DAVIS
PARTNERSHIP
ARCHITECTS

ADDENDUM NO: 03

Date Issued: December 9, 2015

**Re: Red Rocks Community College
Student Recreation Center**
Construction Documents, Dated November 9, 2015
Architect's Project No. 15803.00

Sheet Title:
**ELECTRICAL
POWER 1ST
FLOOR PLAN**

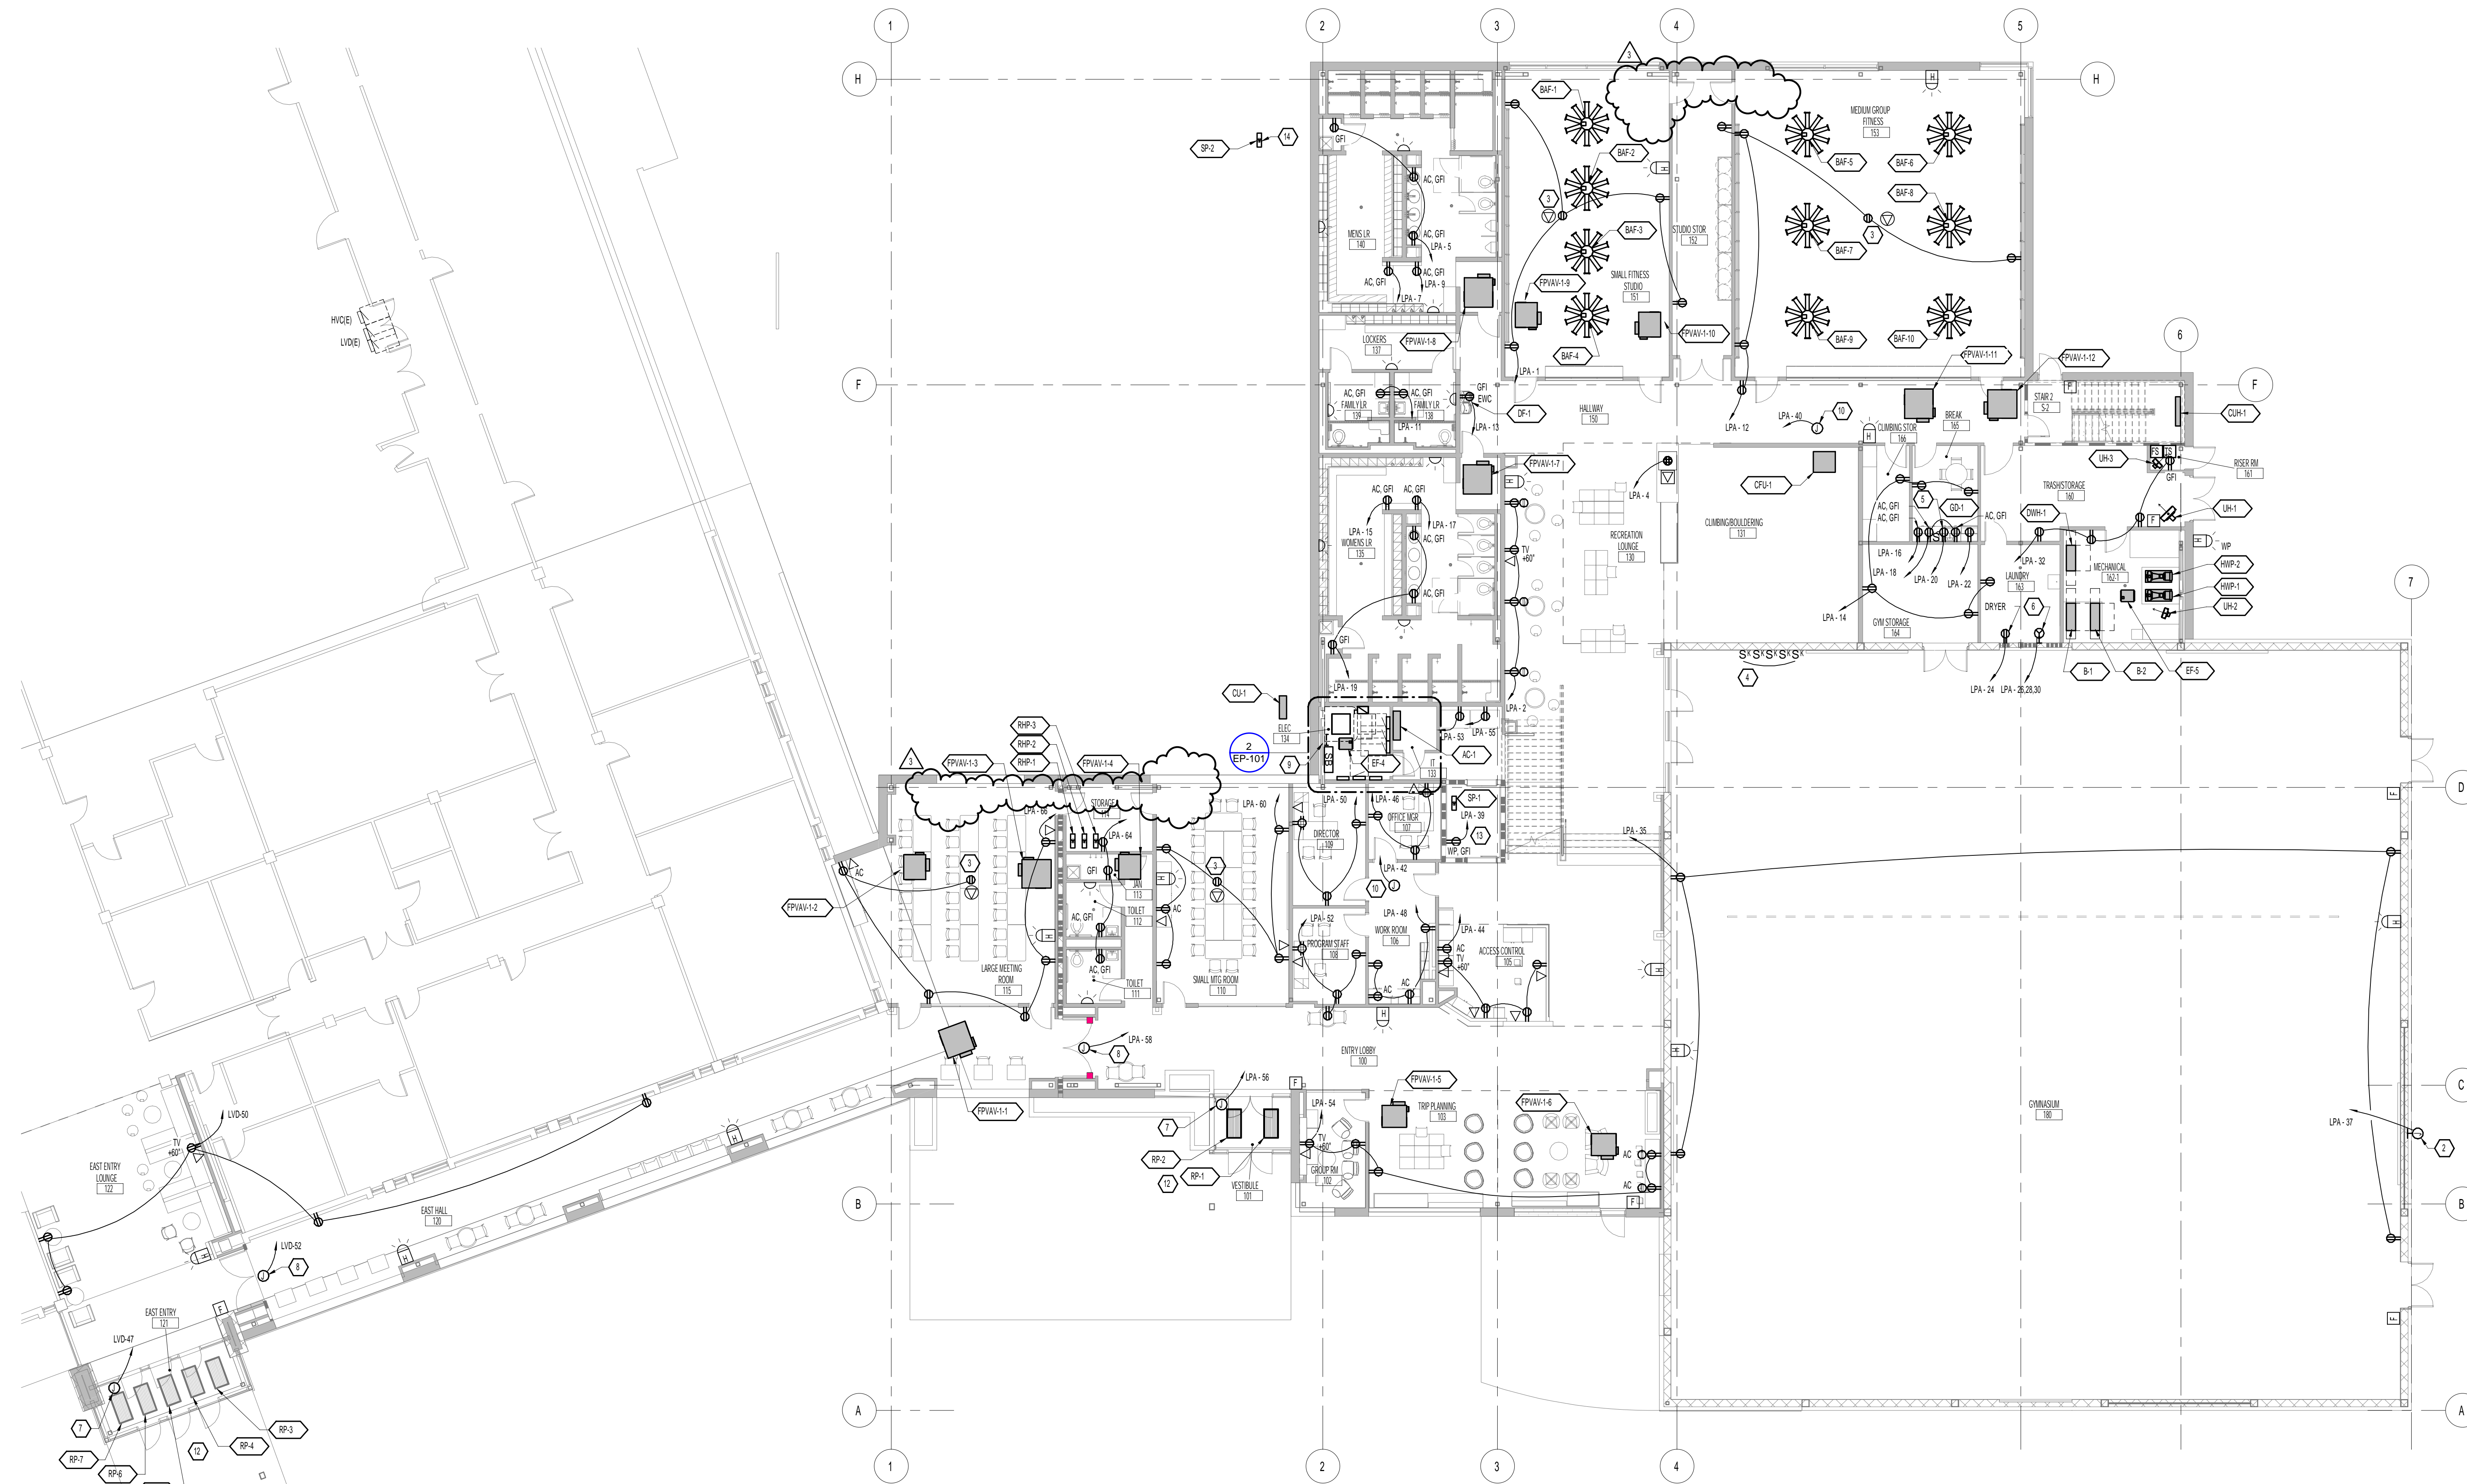
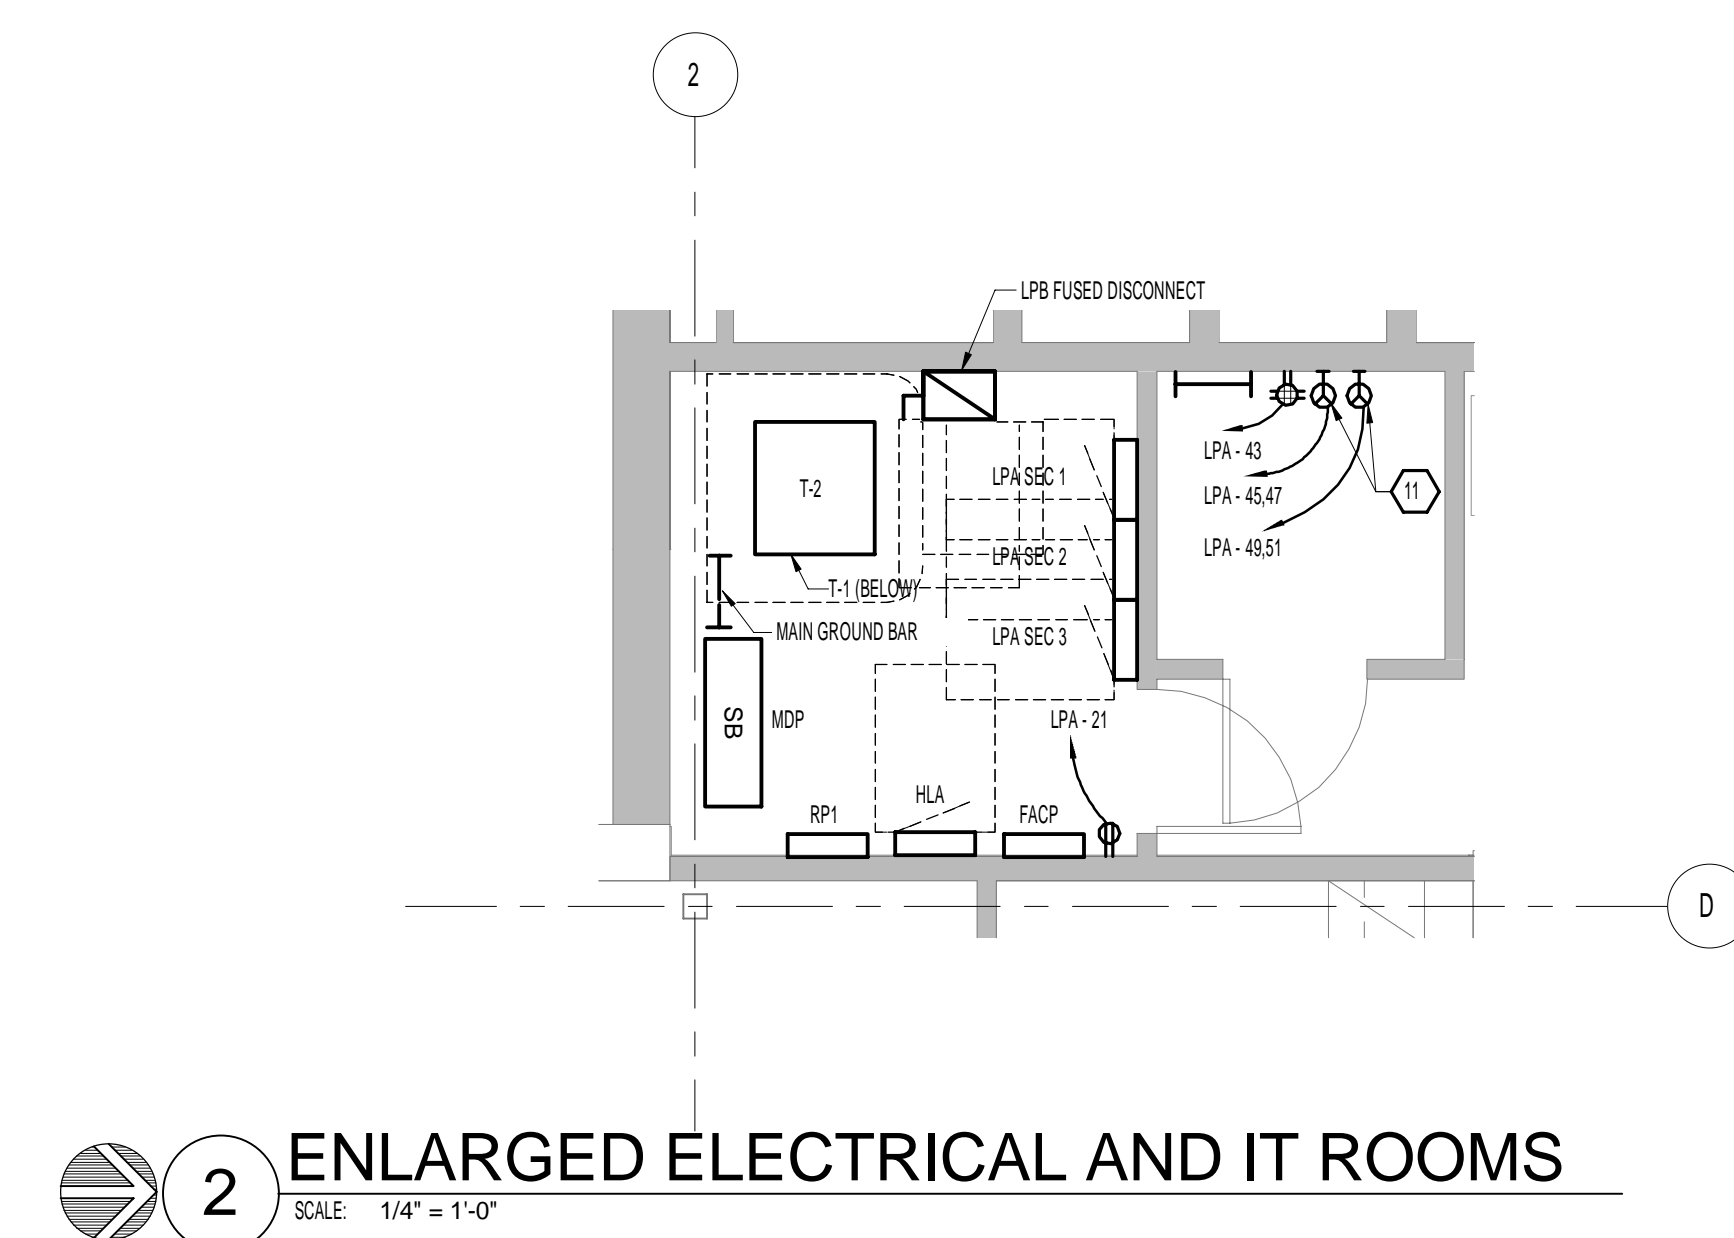
- ADD. #3-44. Concerning manual and motor-operated window shades: Sheet EP-101 (Keynote 1) indicates electrical connections to motorized window shades at locations that sheet A-151 (Coded Note 2) specifies as dual manual roller shades. Please clarify where motorized and non-motorized window shades will be located. **RESPONSE: Has been coordinated with the architectural to match sheet A-151. Sheet EP-101 has been revised and provided in Addendum 3.**

ADD. #3-82. Sheet EP-101 - has been updated to reflect the changes to the motorized shades.
